Planning Commission Meeting

PLANNING COMMISSION AGENDA

Development Review Committee Minutes

On October 7, 2024, plans were submitted for the Harmony Ridge Plat "G" subdivision consisting of 113 townhome lots. The items below include 1) requested changes to the submitted plans, 2) other items required as part of the application and/or 3) informational items regarding city standards.

601

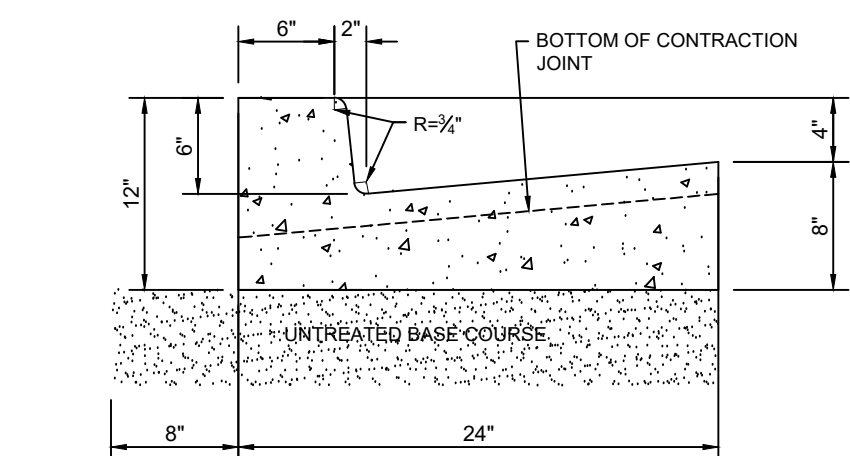
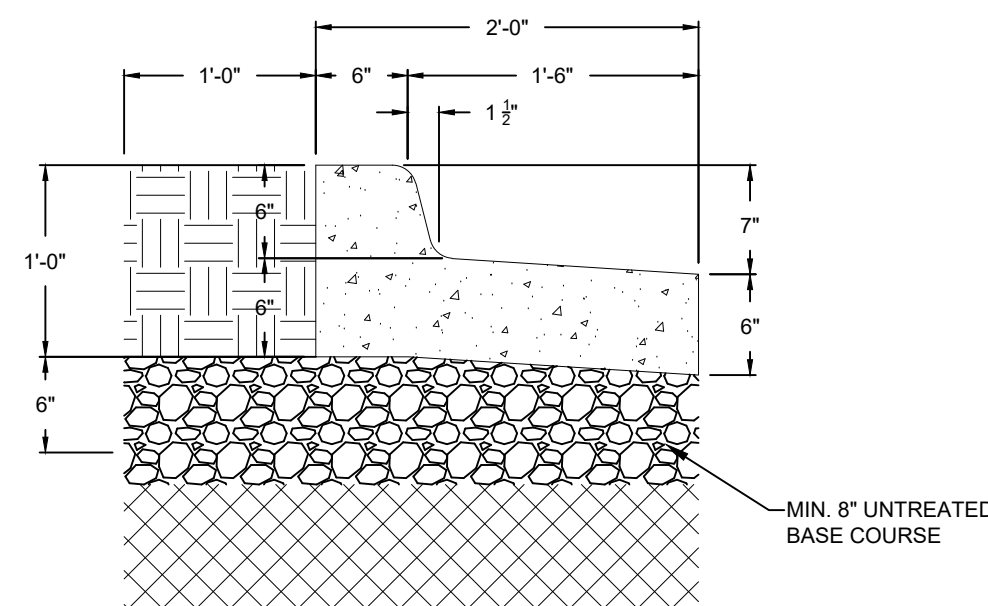
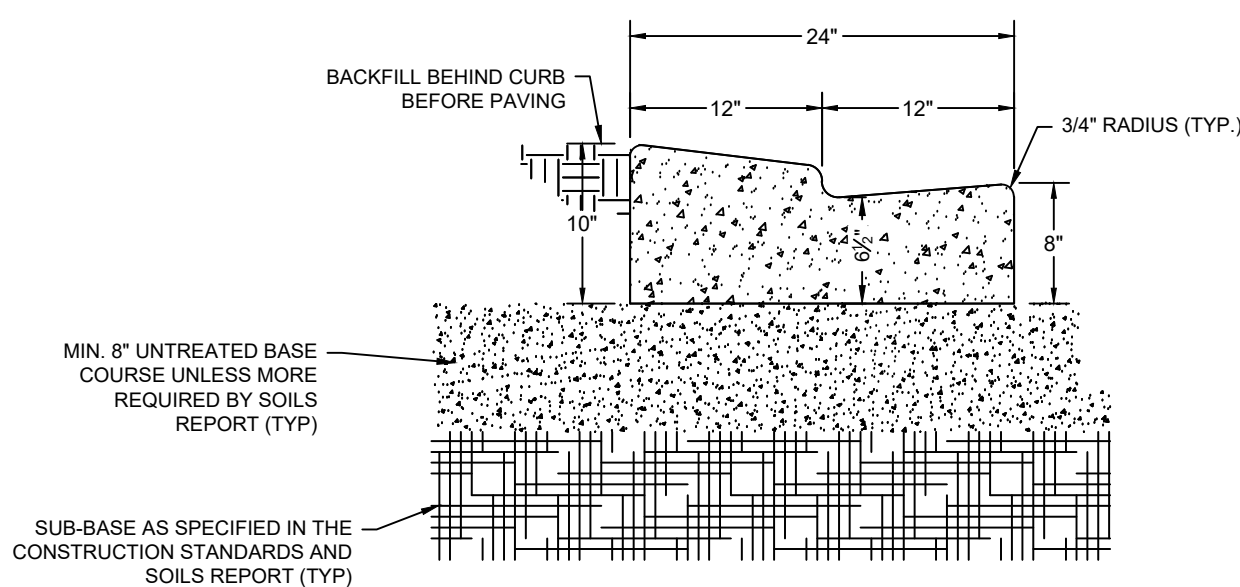
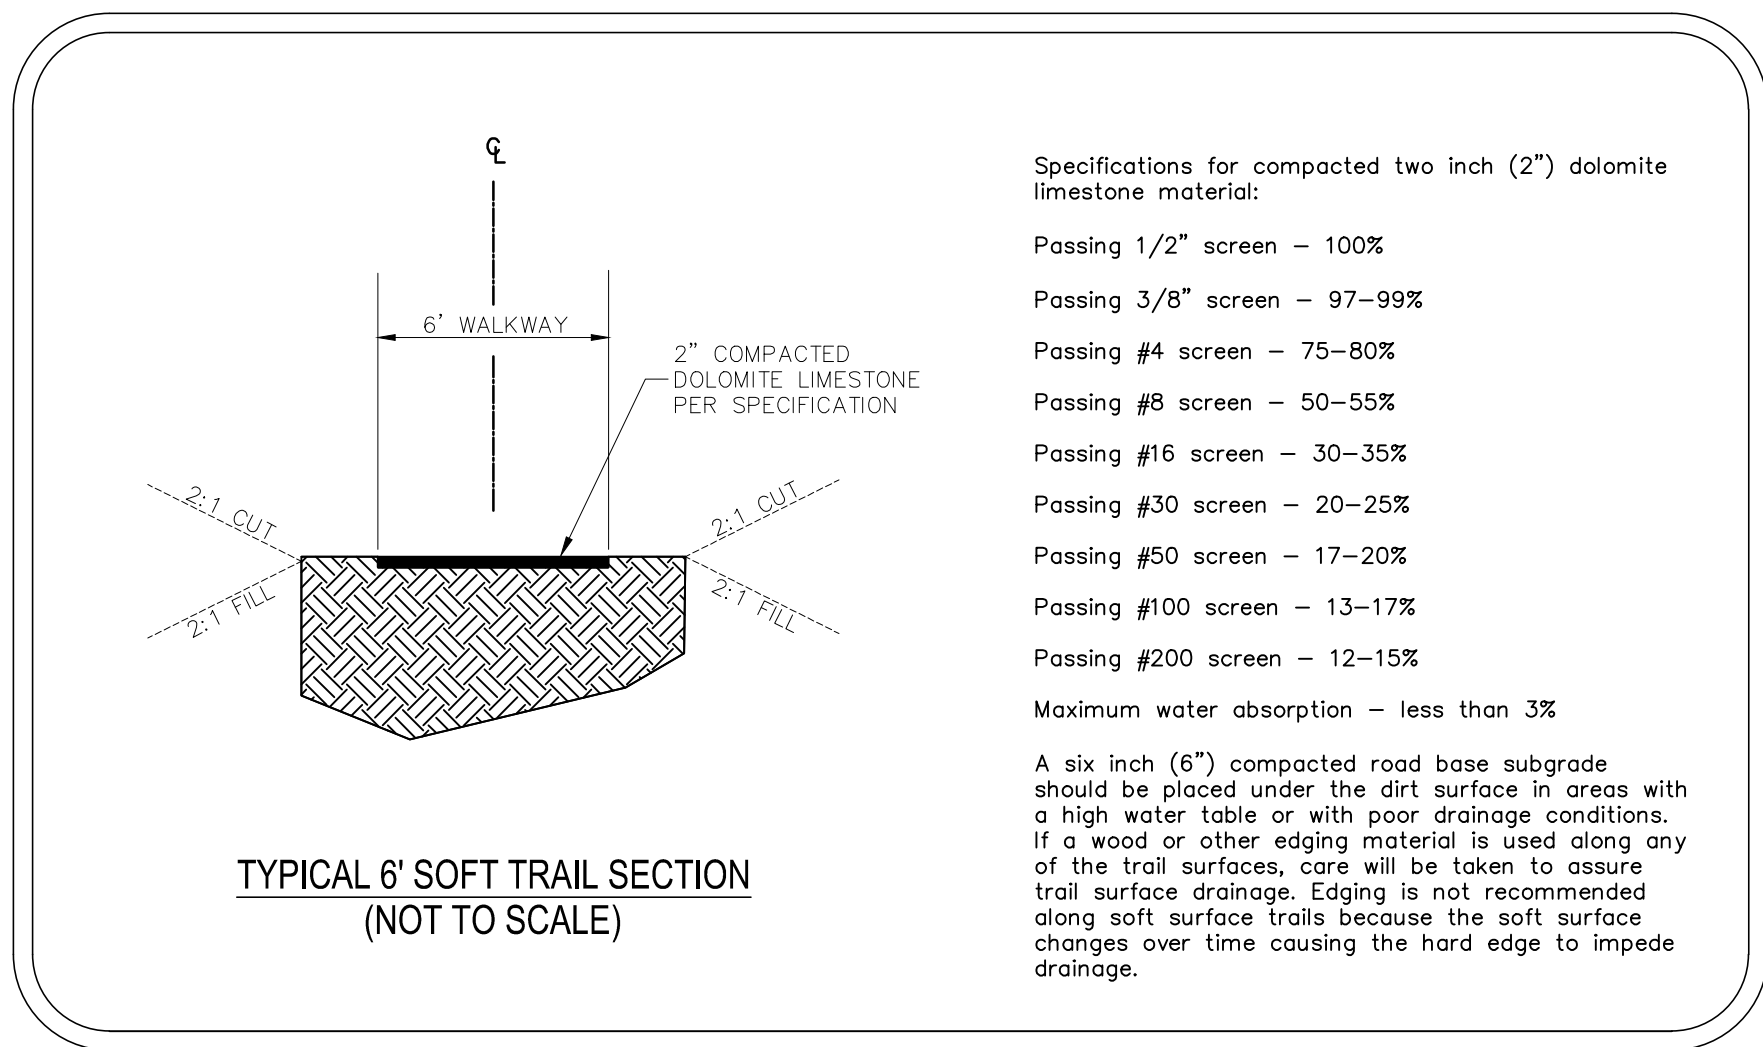
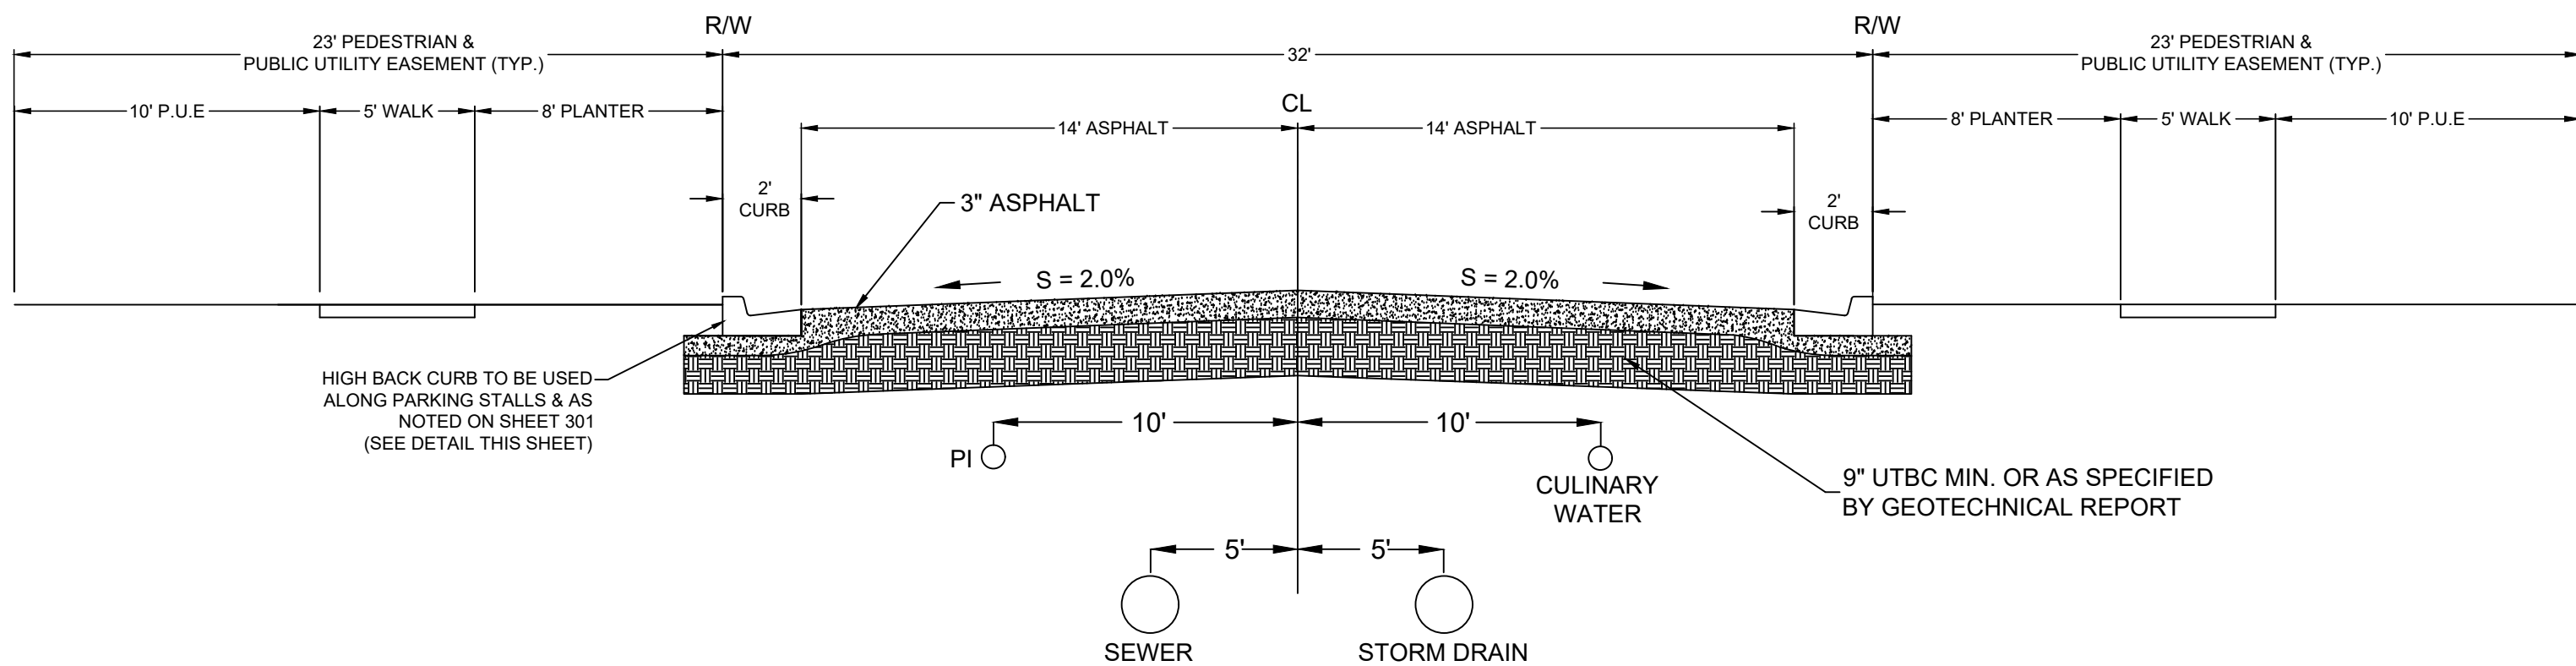
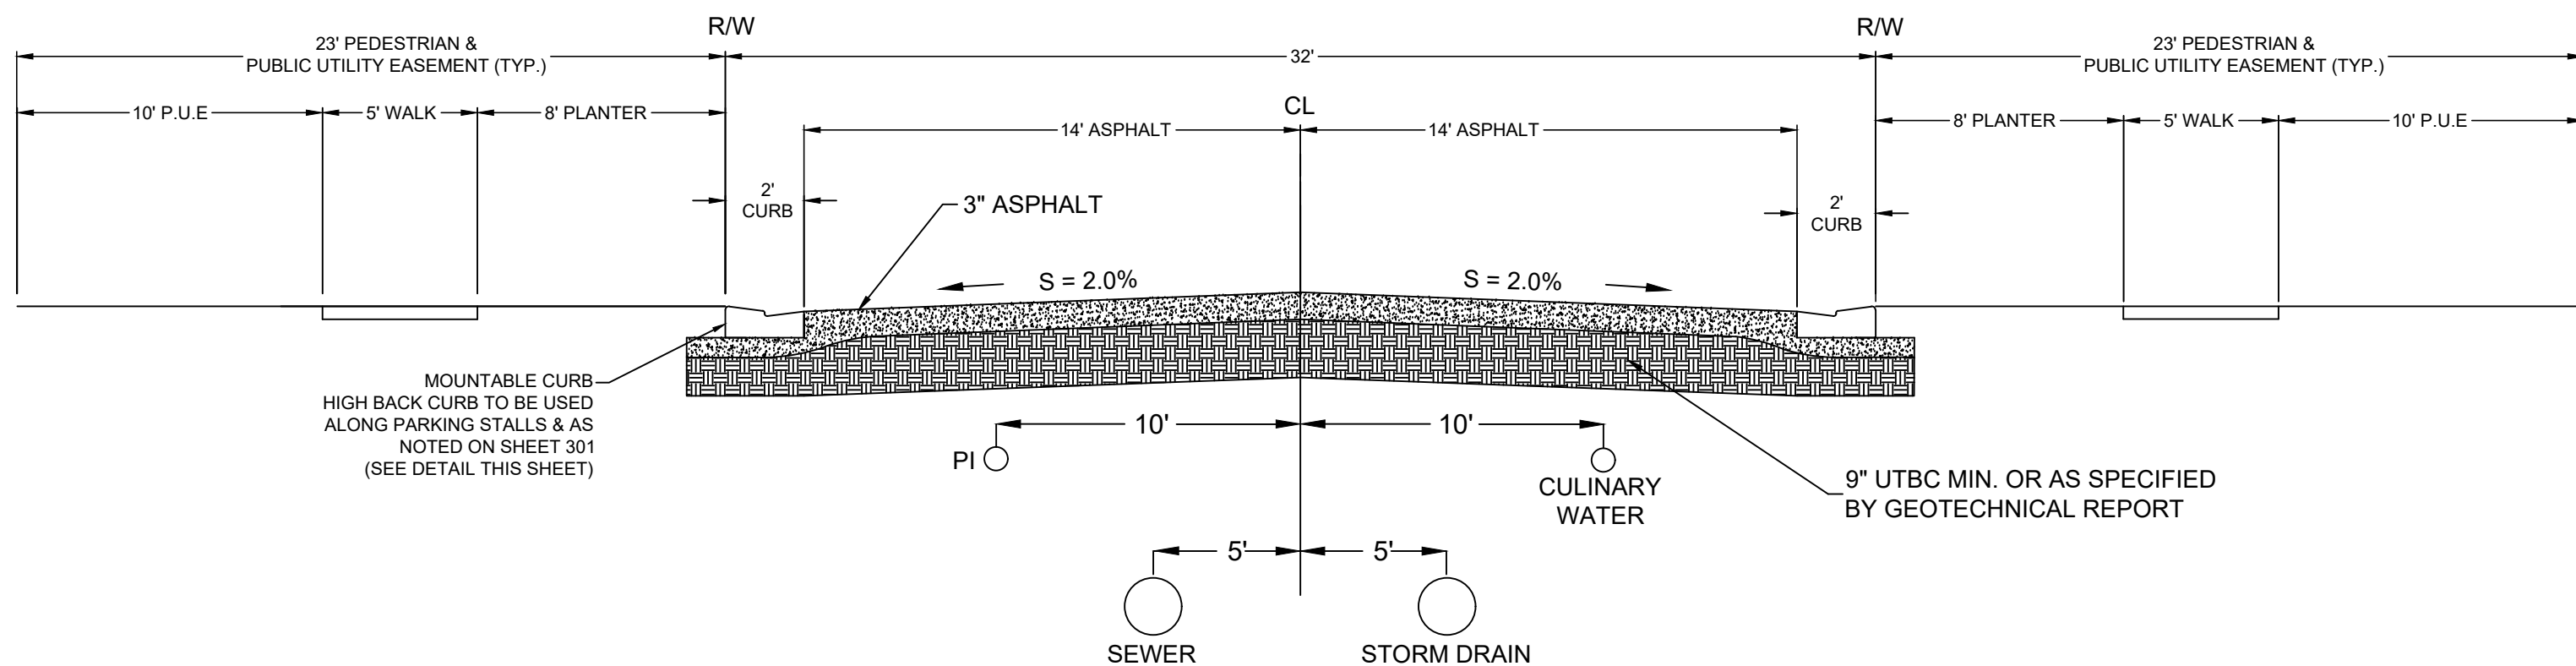
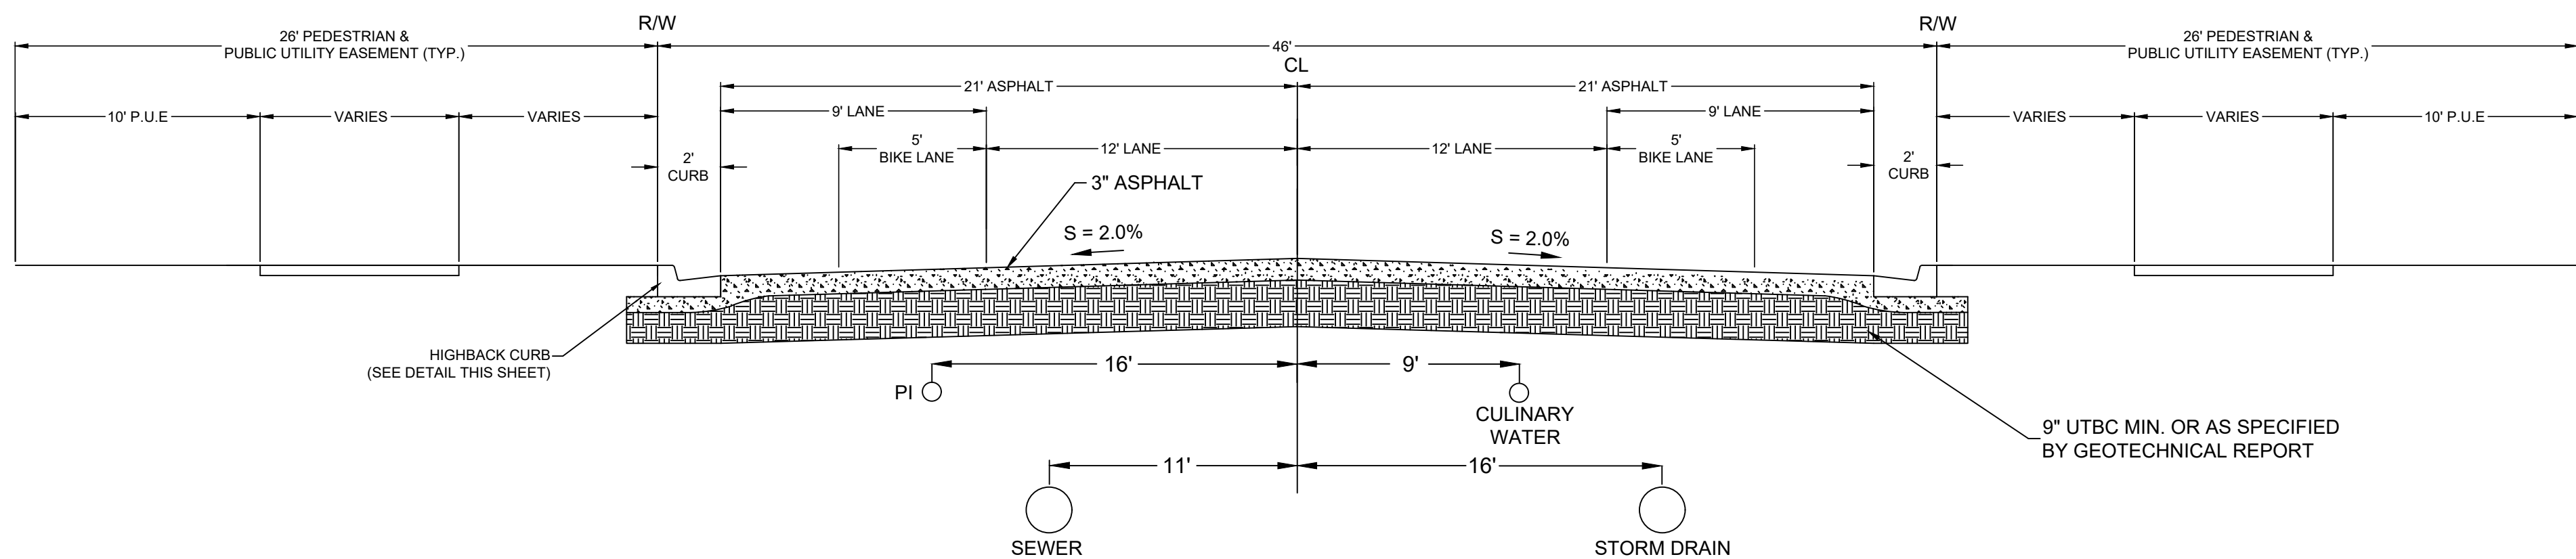
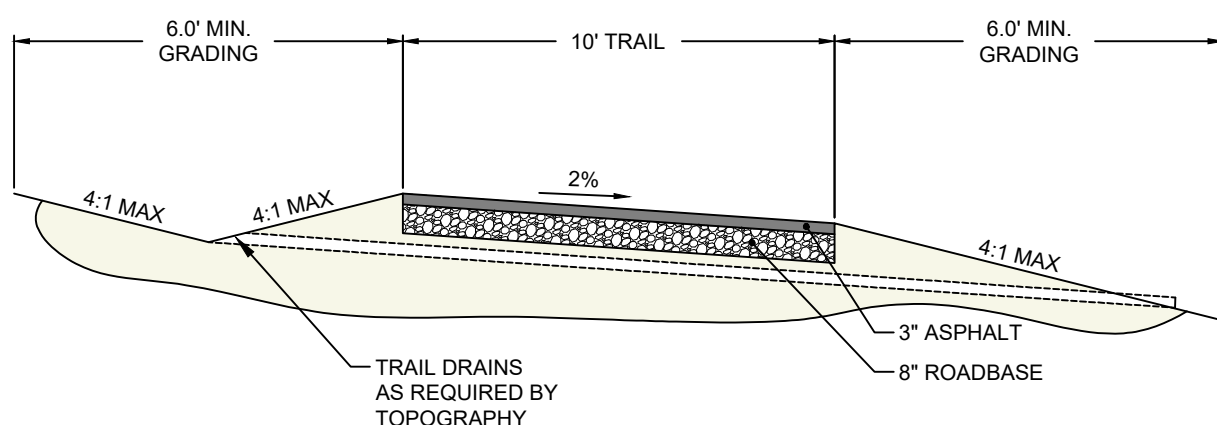
1. Update details to include the double catch basin inlet.
